**CHG UNV 3541
48 Volt Timer
Conversion**

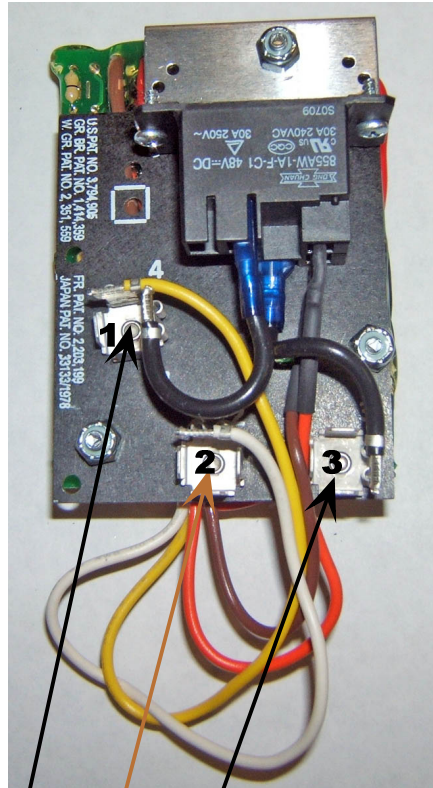
Charger:
Remove the existing relay. Tape the Blue signal wire. Tape the red signal wire. Route the Black circuit breaker wire to pin 1 on the new timer. Route the Black/Tan wire to pin 3 on the timer. Route the White/Tan wire to pin 2 on the timer.

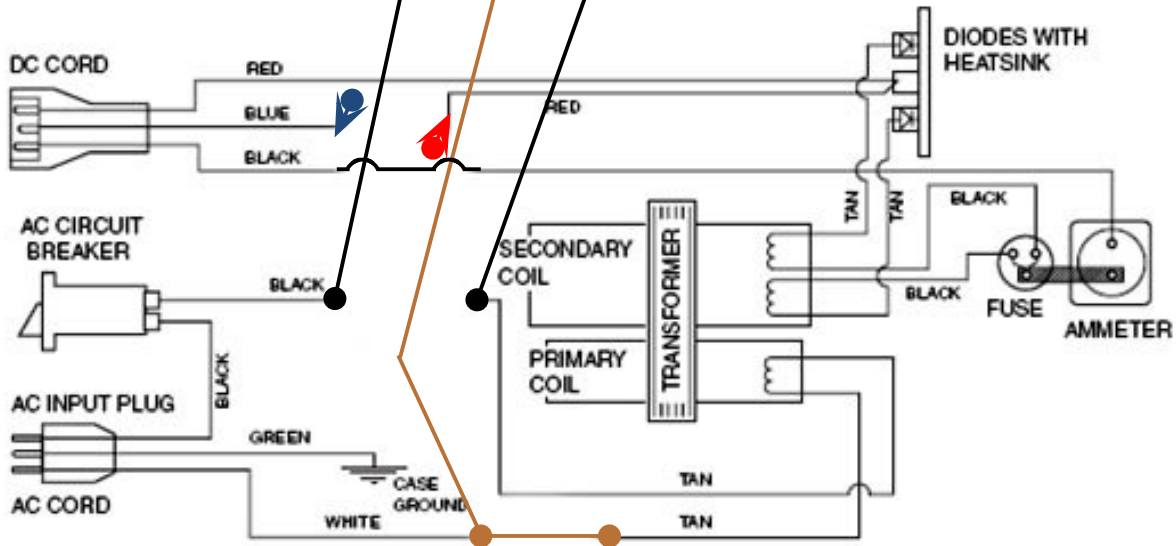
On the car cut the main black negative charger receptacle wire and move to B- on the controller or battery number 6 negative as per bottom diagram.

Older csr connection at B-
